LEWIS AND CLARK MEMORIAL TOWER

SHEET TITLE.
LANDING ELECTRICAL
PLANS

E4-02

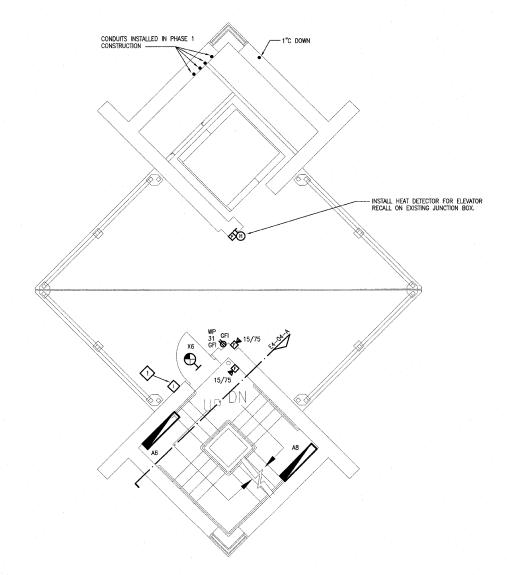
CONDUITS INSTALLED IN PHOCONSTRUCTION	IASE 1	1"C DOWN		
			<u> </u>	
			Install heat detecto recall on existing J	r for elevator
	6 0-		RECALL ON EXISTING J	UNCTION BOX.
	WP 31 GFI ▲15/7:			
	31 15/75 15/75			
A6		AB
